Project: MEADOWS AND PLANTING 2021 GLOUCESTER

Drawing:
Clock Tower Park

Drawn by: JL	Date: Aug 21
Checked by: NC	Date: Aug 21
Approved by:	Date:
Drawing No. ERDFS00_Clocktwr_Proposed Planting_005	Revision B
Drawing Scale: 1:1250 @ A3

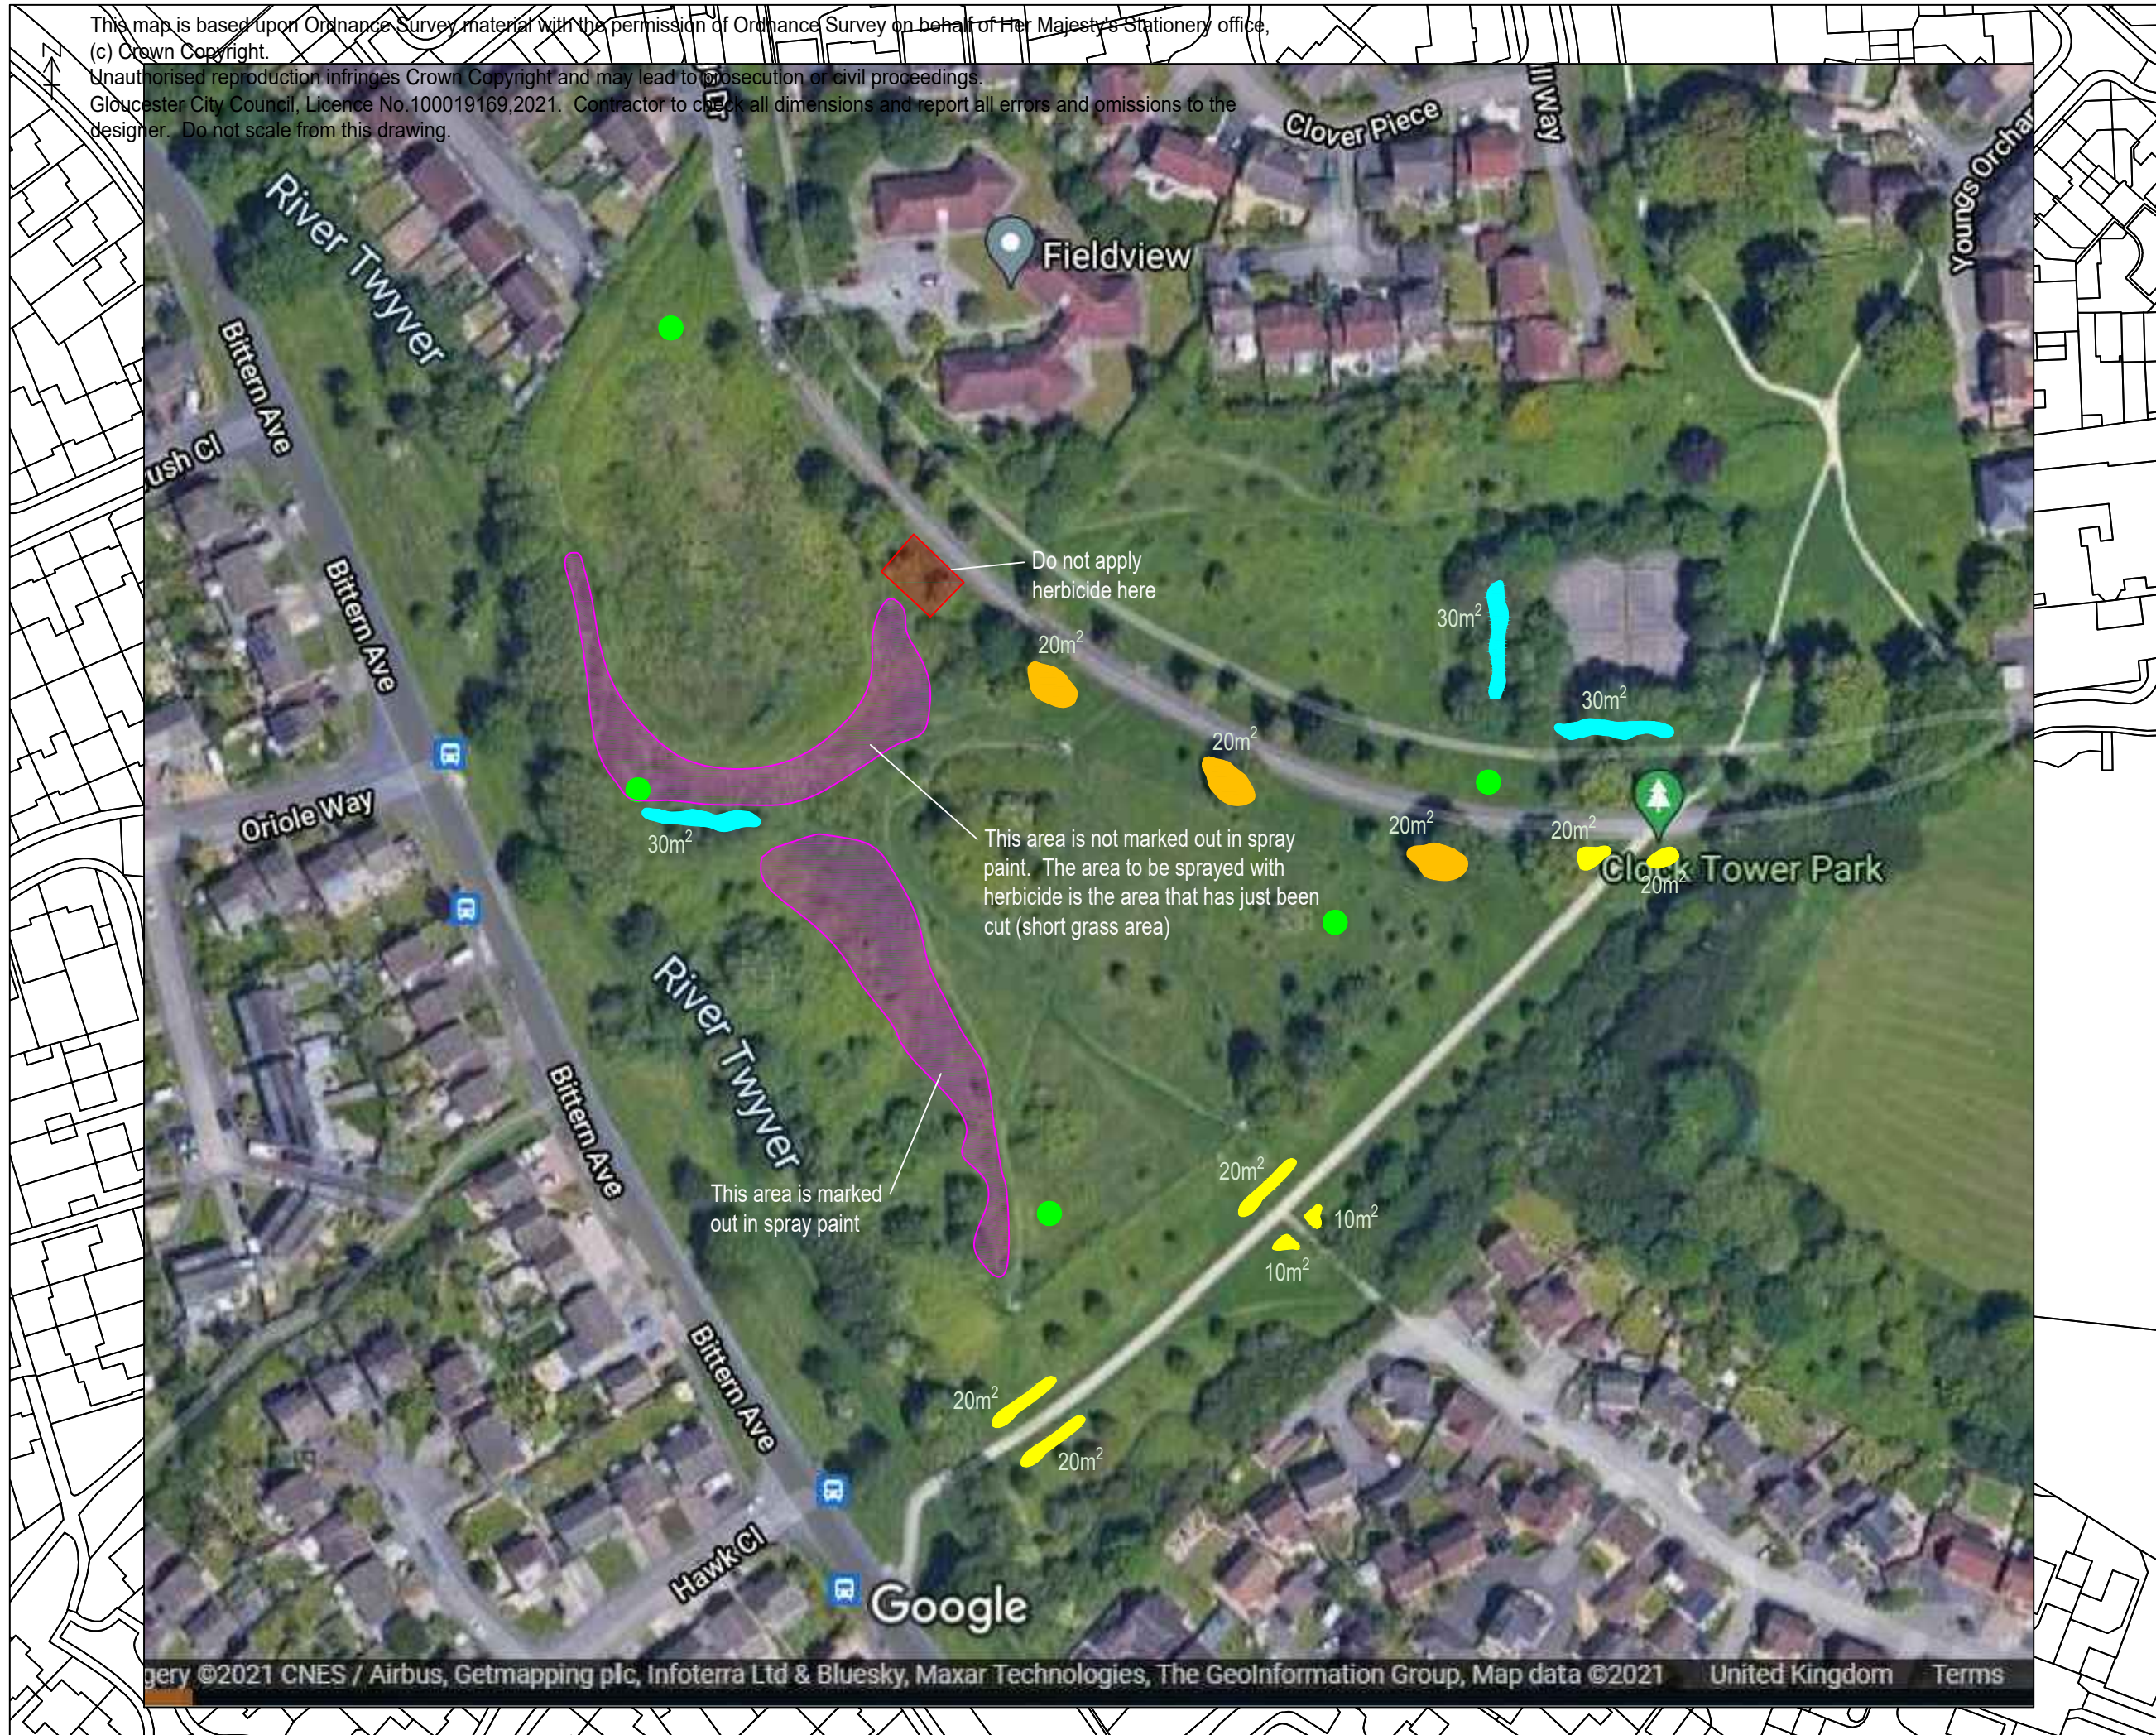
RevA Wildflower area reduced around balancing JL NC Sept 21 pond to avoid bank and trees. Within fenced area tied in with existing and cleared area

RevB Wildflower reduced around pond and notes JL NC Sept 21 added
